9-15-0162-W

SOUTHERN CALIFORNIA EDISON COMPANY

- **Public Comments and Correspondence**

Q&A about San Onofre Spent Fuel Pool Cooling Island Project

Figure 1:

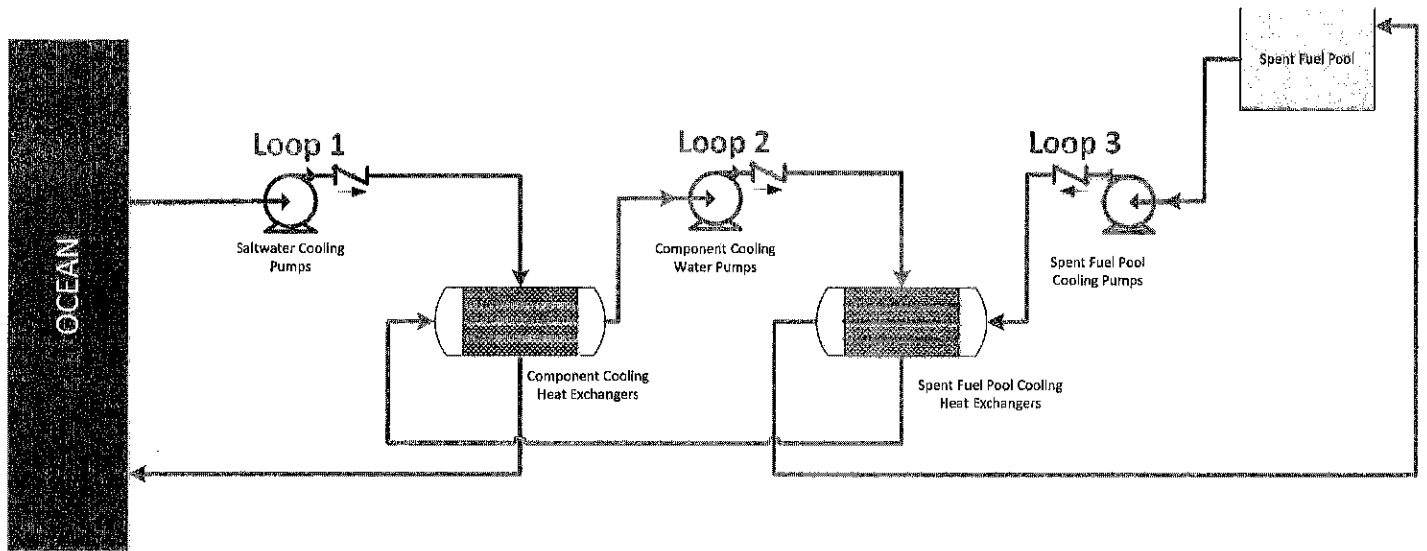
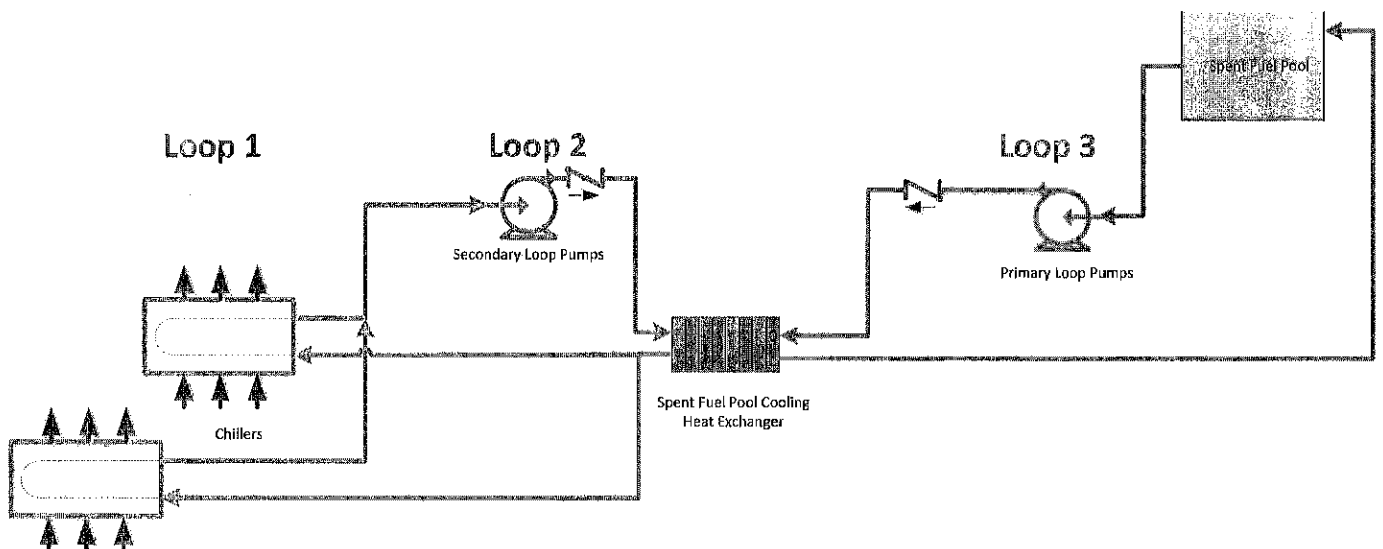
I would love to see an end to the once-through cooling. However, the limited detail on this notice doesn't give me confidence the alternate system is adequate and that it will not present problems of it's own.

If this new spent fuel pool island system fails, what is the backup plan if Edison is allowed to destroy the current cooling system infrastructure?

A: The proposed Spent Fuel Pool Island cooling system is composed of two (2) separate water loops. The secondary loop will continuously circulate fresh water through the chillers to the secondary side of the new Spent Fuel Pool Heat Exchanger and back through the chiller (Figure 2). It requires an initial system fill of approximately 1000 gallons, which will come from the city supplied service water system. In contrast, the existing secondary cooling system is a once through system passing approximately 16,000 gallons per minute of ocean water. The proposed Spent Fuel Pool Island cooling system is essentially a 'closed' system in that it does not require a continuous supply of once-through cooling water; however, it does require makeup as described below.

The primary loop will continue to operate in the same manner as it does now. Water from the Spent Fuel Pool is circulated through the primary side of the new Spent Fuel Pool Heat Exchanger and is returned to the pool. This loop is currently subject to evaporative losses of approximately 900 gallons per week and will not change with the new Spent Fuel Pool Island cooling system. The source of that makeup water will continue to be our demineralized water system, which ultimately gets water from the city supplied service water system. Makeup needs will continue to decrease as the fuel continues to cool.

Figure 2:

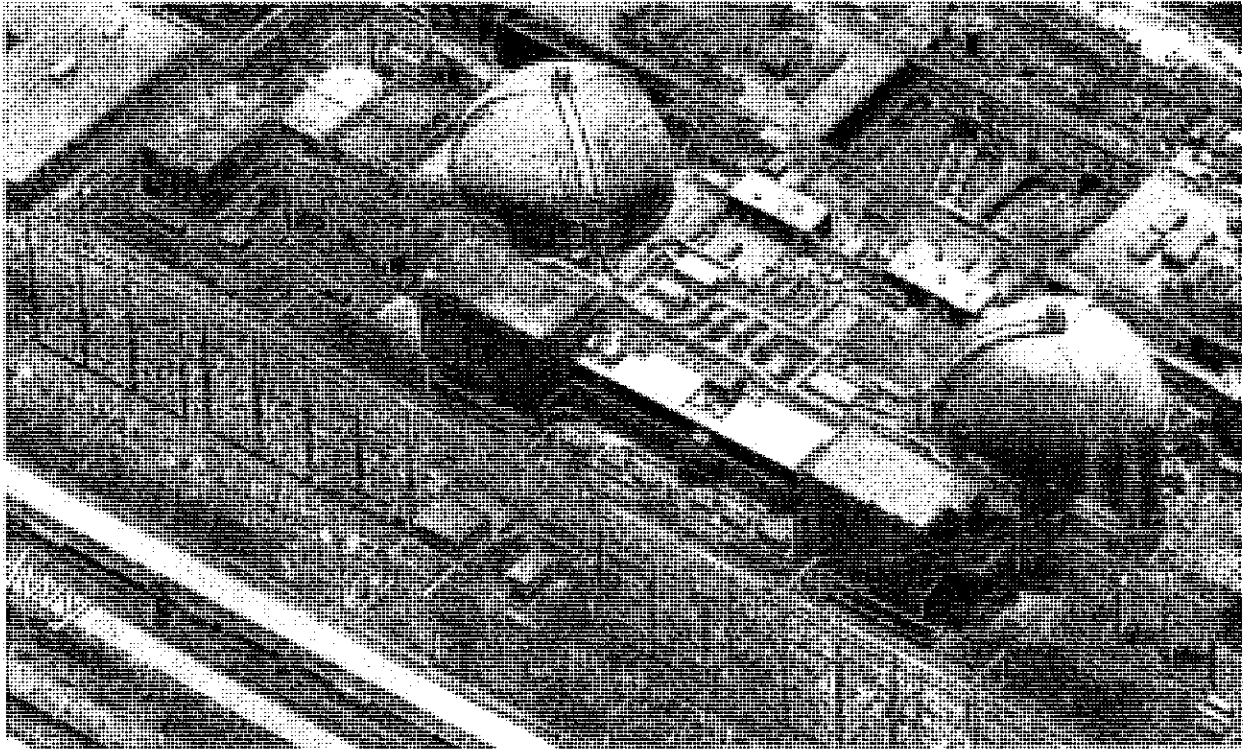
Where are the technical specifications?

Their reply to the 14th question doesn't make sense. "The secondary loop includes two (100% redundant) pumps with two chillers per unit. The current head load ... requires a total of three chillers units." There's not 100 percent redundancy when three of four chillers are needed, even if the chiller units can be cross-tied. And they dodged entirely the sub-question about single points of failure (unless providing crappy responses is the single failure).

A diagram of the proposed Spent Fuel Pool Island cooling system consisting of two cooling loops is presented as Figure 2. A composite rendering of the proposed equipment superimposed on an existing plant photo is provided in Figure 3.

Figure 3 (rendering):

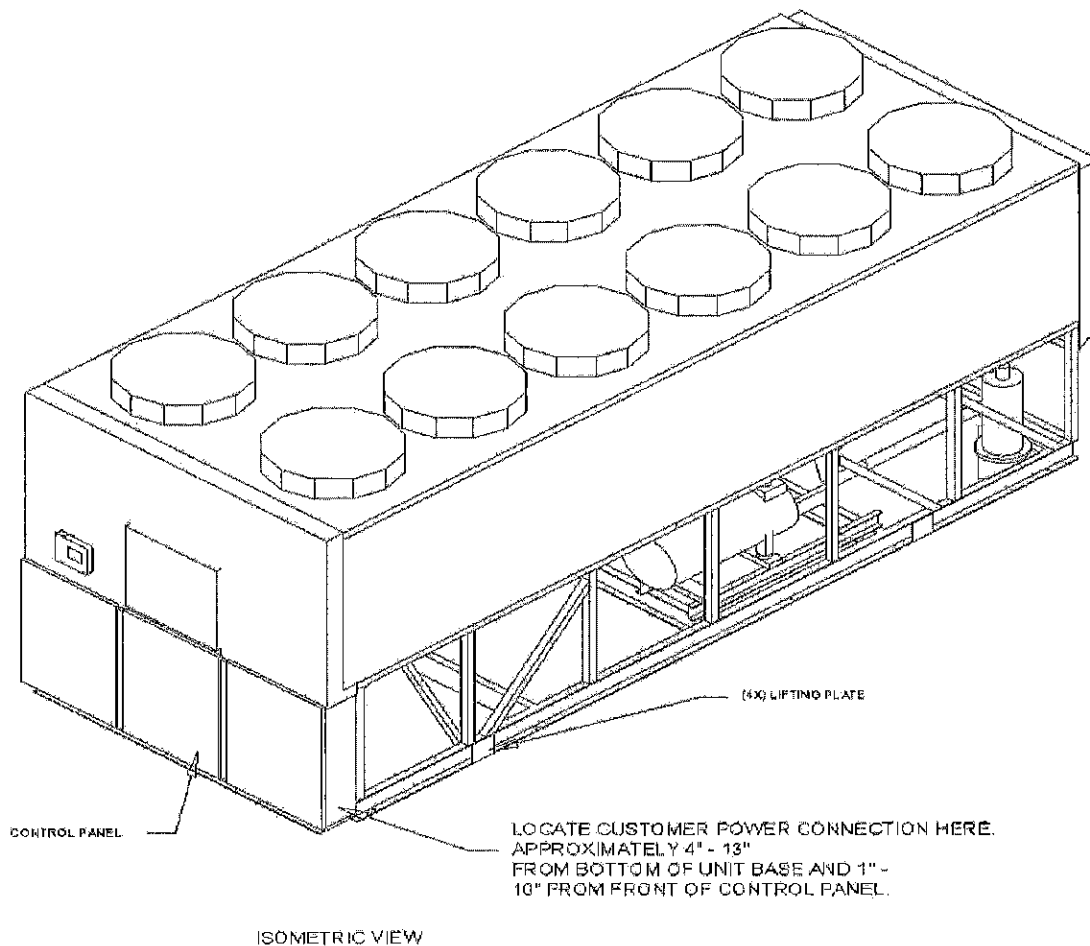
Sup Q3: I would also advise the California Coastal Commission question how wise it is for all the chiller area storm drains to be plugged in this volatile environment.

A: See Supplemental Question 3 above, SCE has no plans to plug any drains as part of installing this Spent Fuel Pool Cooling System.
